PLANS AND SPECIFICATIONS

FOR NEW BUILDINGS.

No. 181 Submitted May 10<sup>th</sup> 1871

LOCATIONS.

*Plans for erecting May 1871*

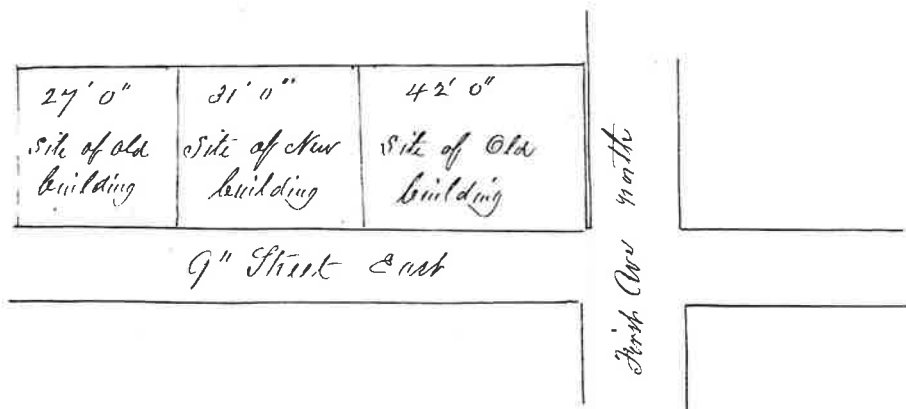
This is intended to show how the new building which is referred to in the printed form and is to be erected between the two buildings already erected on the north west corner of First Avenue and Ninth Street, New York. The lot is situated in this way.

There is a building on east end of lot which fronts on First Avenue  $23 \times 42$  and there is a building on the west end of lot which is  $23 \times 27$ . The new building is to be built between the two foregoing described buildings and is to be  $23 \times 31$ .

The new building and the building on the west end of lot front on Ninth Street and the building on east end of lot fronts First Ave. It is intended by the owner that the new wall of the building on the east end of lot and the side wall of the building on the west end of lot adjoining the new building are to form side walls of new building. It is intended to carry up the side wall of building on west end of lot five feet above the roof as the same now stands in order to make it as high required for the new building. The foundations of the aforesaid walls are twenty inches thick built of stone and the upper walls 12 inches thick built of bricks, all laid in lime and sand mortar.

The beams of the new building are not to be inserted in the old walls but are to run from front to rear into the two new walls which are to be built for the new building. The side

wall of building on the west end of lot is now forty one feet high and the rear wall of building on east end of lot is now forty six feet high.

The owner wishes to extend a galvanized iron cornice around the building on east end of lot and put up a bathhead on roof with stairs leading thereto and place three or four water closets in said building.

The building on the west end of lot is to have no alteration except to raise up the wall as before mentioned and make the wall good where required.

The owners respectfully request that the said old walls intended to be used in the said new building be examined and that a permit be granted that they be used as hereinbefore mentioned and that such alterations as are hereinbefore mentioned be allowed to be made in the buildings to which said walls belong.

As the walls of adjoining buildings will not be used for beams to rest upon, I am of opinion the same can be used in manner proposed
